# UNITED STATES PATENT AND TRADEMARK OFFICE

10/706,949

<b>Office Action Summary</b>	<b>Application No.</b> 10/706,949	<b>Applicant(s)</b> SONG ET AL.	
	<b>Examiner</b> Matthew G. Kayrish	<b>Art Unit</b> 2627

## **DETAILED ACTION**

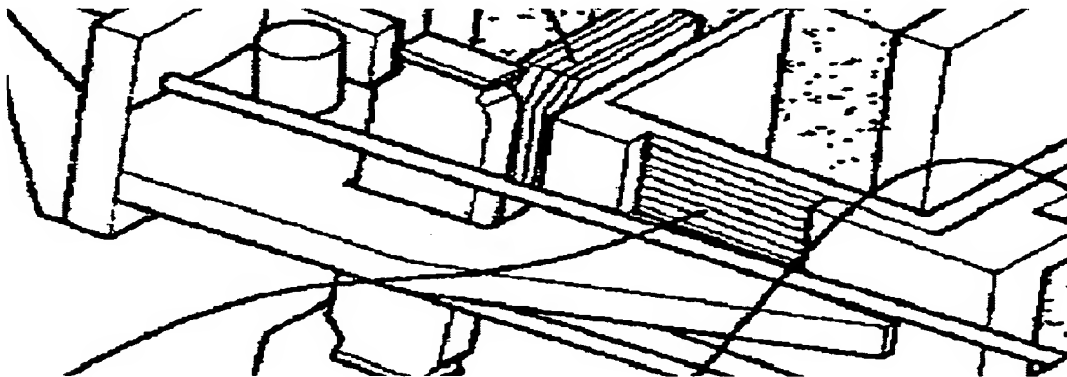
Wherein the receiving hall has shoulders at opposing sides thereof (refer to figure below), and wherein the at least one location where changes of the actuator occur most frequently are the shoulders (changes will most frequently occur at the shoulders because they are at the greatest distance from the center).
